Subject: Submittal of Formal Revision 4 of the NUHOMS® HD System Safety Analysis Report (TAC NO. L23738).

TN Response to NRC Peer Review Comments on the NUHOMS® HD System

NUHOMS HD Peer Review Comments
December 7, 2005

Table 1 - Issues for TN to Address/Correct

Figure 3-2
Finite Element Model and Boundary Conditions WE 15x15 and WES 15x15

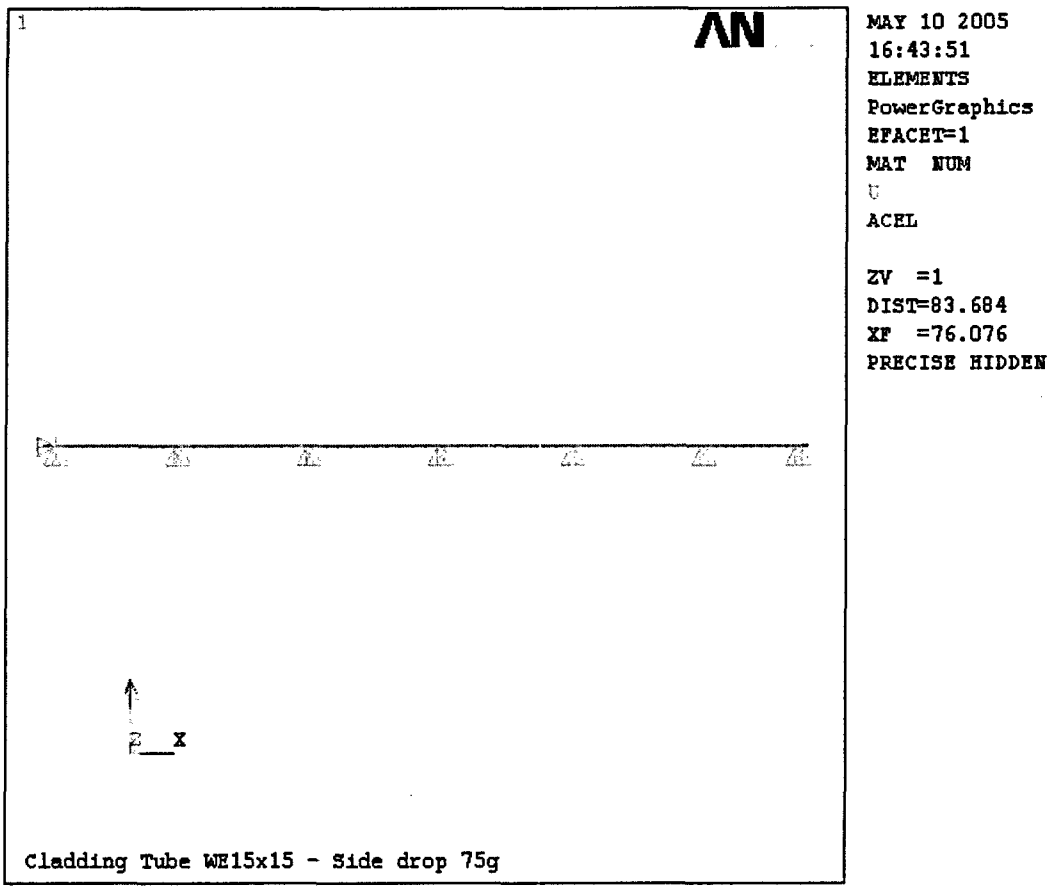
Table 3-13	Response to RAI#2 and consistent fuel type abbreviation call out (comment from Peer Review #1)
Figure 3-2	Response to RAI#2 and consistent fuel type abbreviation call out (comment from Peer Review #1)
Figure 3-3	Response to RAI#2 and consistent fuel type abbreviation call out (comment from Peer Review #1)
Figure 3-4	Response to RAI#2 and consistent fuel type abbreviation call out (comment from Peer Review #1)
Figure 3-5	Response to RAI#2 and consistent fuel type abbreviation call out (comment from Peer Review #1)
Figure 3-6	Response to RAI#2 and consistent fuel type abbreviation call out (comment from Peer Review #1)
Figure 3-7	Response to RAI#2 and consistent fuel type abbreviation call out (comment from Peer Review #1)

Figure 4-39
Comparison of the Axial Heat Profiles in the FE Model and in Ref. [4]

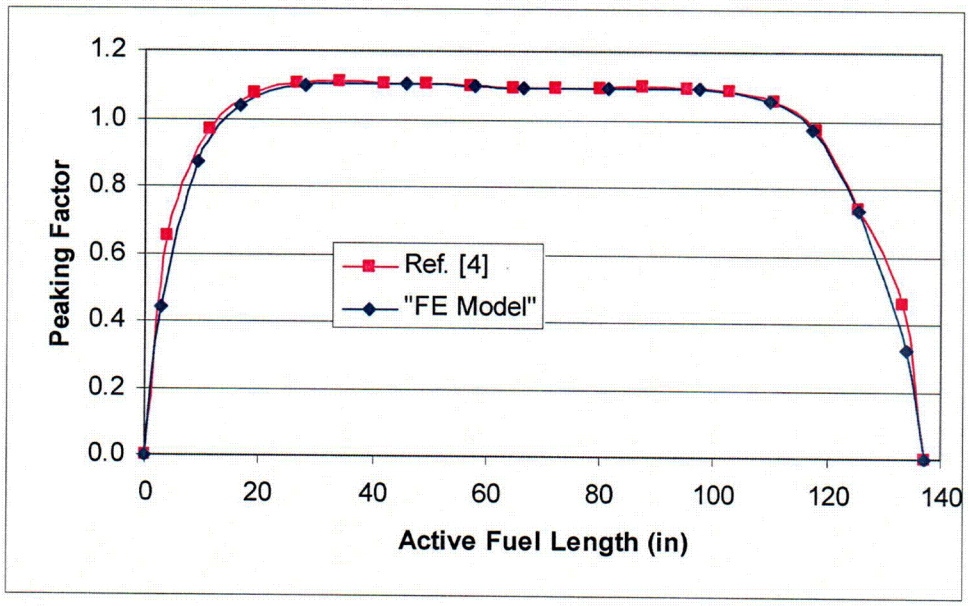
Figures 4-39, 4-47,	Consistent fuel type abbreviation call out (comment from Peer Review #1)
5-ii	Consistent fuel type abbreviation call out (comment from Peer Review #1), typo
5-1	Consistent fuel type abbreviation call out (comment from Peer Review #1)
5-3	Typo (change ENDFB-IV to ENDF/B-V)
5-4	Consistent with Technical Specifications and fuel type abbreviation call out (comment from Peer Review #1)
5-5	Typo (change ENDFB-IV to ENDF/B-V) and fuel type abbreviation call out (comment from Peer Review #1)
Table 5-7	Consistent fuel type abbreviation call out (comment from Peer Review #1)
Table 5-9	Consistent fuel type abbreviation call out (comment from Peer Review #1)
Table 5-10	Consistent fuel type abbreviation call out (comment from Peer Review #1)
Table 5-13	Consistent fuel type abbreviation call out (comment from Peer Review #1)
6-ii	Typo
Table 6-1	Consistent with Technical Specifications
Table 6-3	Consistent fuel type abbreviation call out (comment from Peer Review #1) and consistent with Technical Specifications

Figure 7-1
32PTH DSC Confinement Boundaries and Welds

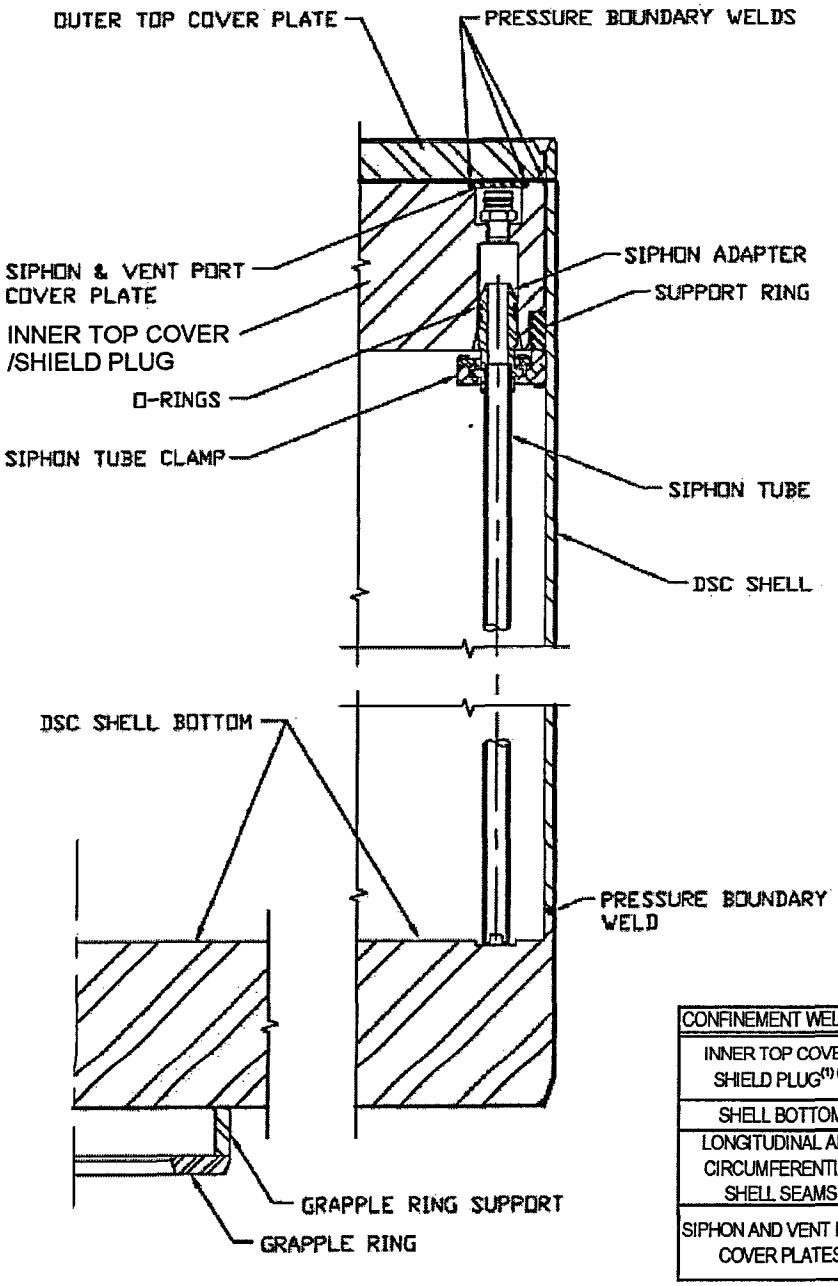
Page Number	Change Description and Reason for Change
7-5	Remove Code Case N-595-3 (comments from Peer Review #23 and #32)
Figure 7-1	Editorial change and add detail description of confinement boundary welds (Action per 11/18/05 telcon with NRC Staff)
8-1	Replace air with nitrogen; response to Peer Review Comment #15, typo
8-2	Response to Peer Review Comments #5 and #10
8-3	Replace air with nitrogen; response to Peer Review Comments #9 and #11; editorial change, add note 1
8-4	Replace air with nitrogen; response to Peer Review Comments #6, #15, and #35; editorial correction; terminology consistency
8-5	Response to Peer Review Comment #6; action per 11/18/05 telcon with NRC Staff for adding pressure test of inner cover/shield plug to shell weld; editorial changes
8-6	Replace air with nitrogen; Action per 11/18/05 telcon with NRC Staff; editorial correction; response to Peer Review Comments # 12 and #35

Figure 12-2
Heat Load Zones

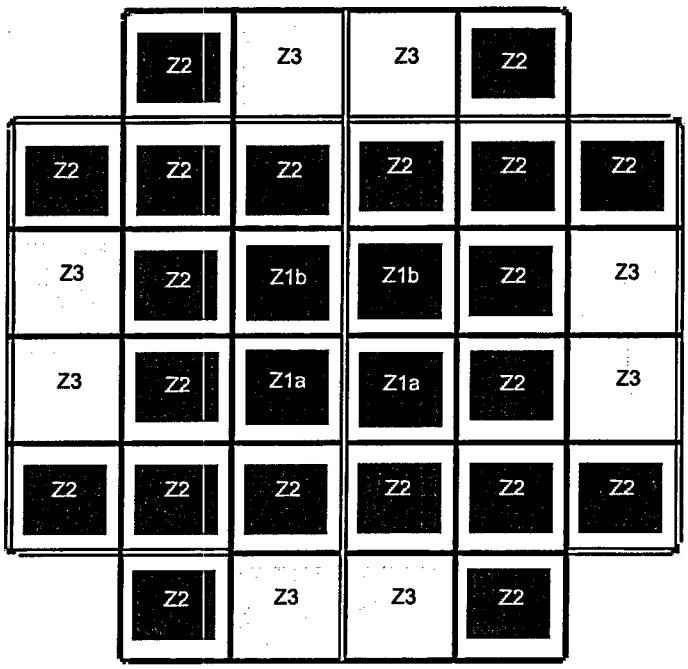
Page Number	Change Description and Reason for Change
Figure 12-2	Consistent with Technical Specifications
B12-9	Replace air with nitrogen
B12-10	Response to Peer Review Comment #6
B12-11	Replace air with nitrogen and clarity regarding "inner top cover/shield plug" for consistency
B12-13	"/Annulus" deleted for consistency, an editorial correction, and clarity regarding "inner top cover/shield plug"
B12-14	"/Annulus" deleted for consistency
Chapter 13 pages 13-i, 13-1, 13-2, 13-3, 13-5 through 13-8, 13-10, and Table 13-1	Consistent with current Quality Assurance Program Description Manual
